ATmega640/1280/1281/2560/2561 Silicon Errata and Data Sheet Clarification

Silicon Errata and Data Sheet Clarification

Figure 3-1. Clock Distribution

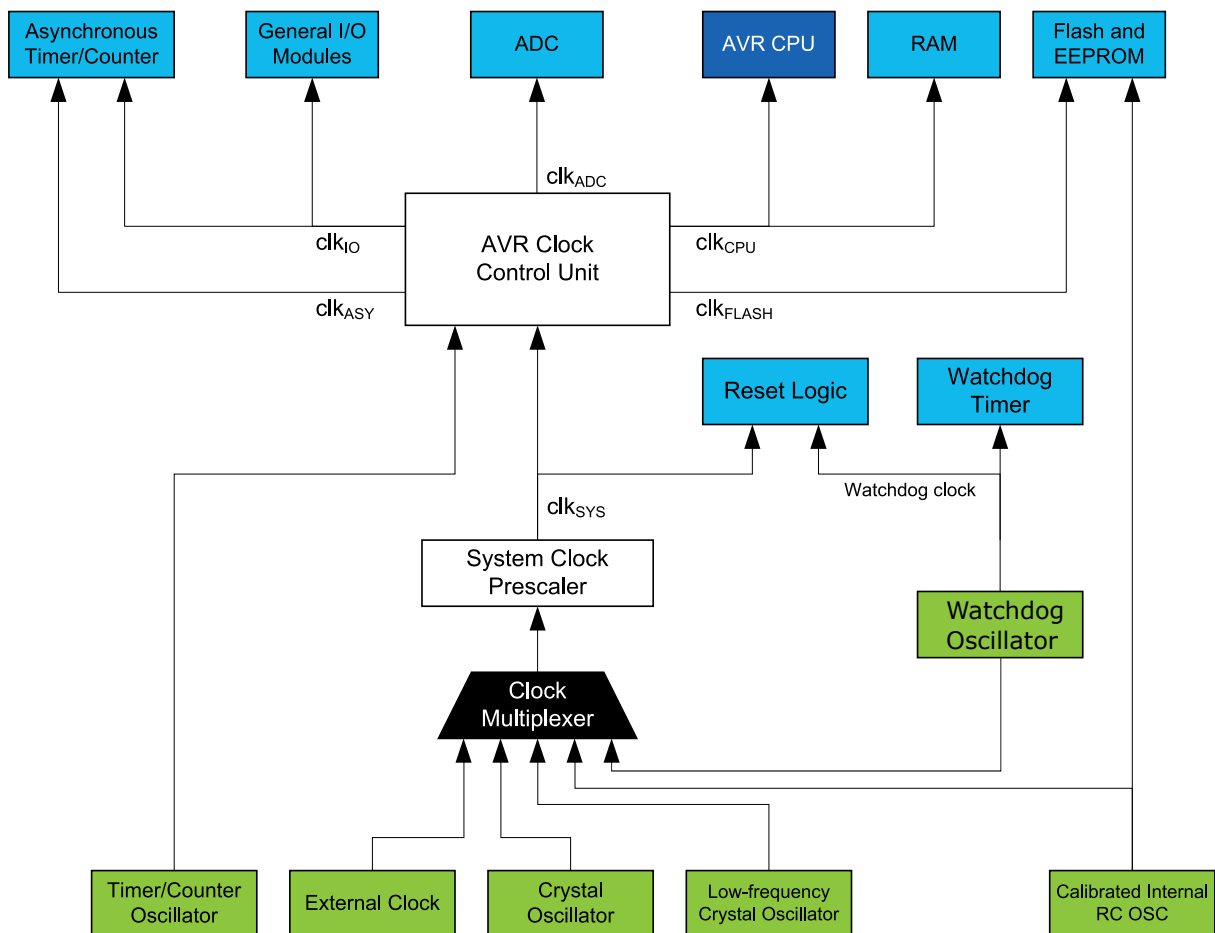
A clarification for the “*Clock Systems and Their Distribution*” section has been made.

Figure “*Clock Distribution*” presents the different clock systems in the ATmega640/1280/1281/2560/2561 and their distribution. All of the clocks need not be active at a given time. The clocks to modules not being used can be halted using different sleep modes, as described in the “*Power management and Sleep Modes*” section, to reduce the power consumption.

Figure “*Clock Distribution*” helps select an appropriate sleep mode.

Figure 3-2. Output Compare Modulator, Timing Diagram

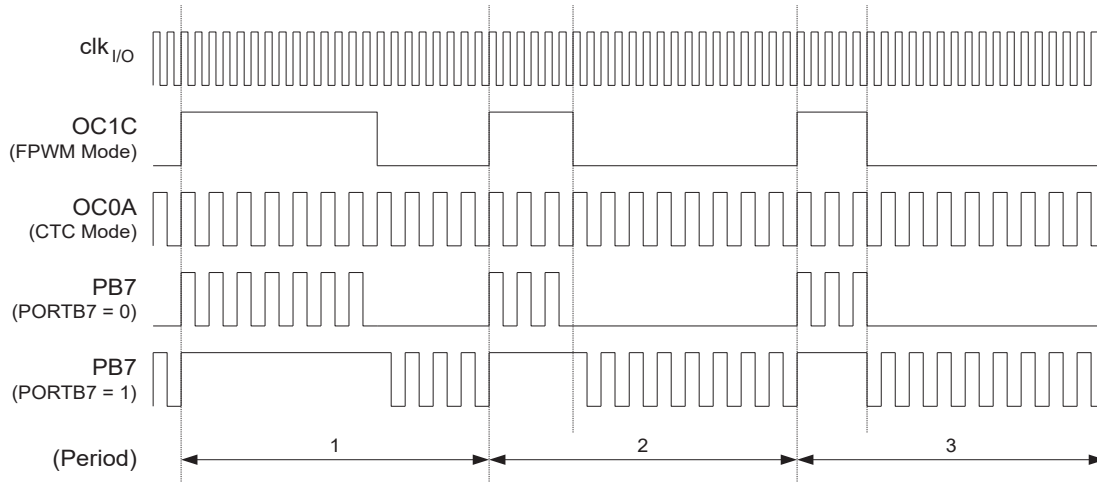
A clarification for the “*Timing example in the Output Compare Modulator*” has been made.

The following figure illustrates the modulator in action. In this example, the Timer/Counter1 is set to operate in fast PWM mode (non-inverted), and Timer/Counter0 uses CTC waveform mode with toggle Compare Output mode (COMnx1:0 = 1).

In this example, **Timer/Counter0** provides the carrier, while the modulating signal is generated by the Output Compare unit C of the Timer/Counter1.
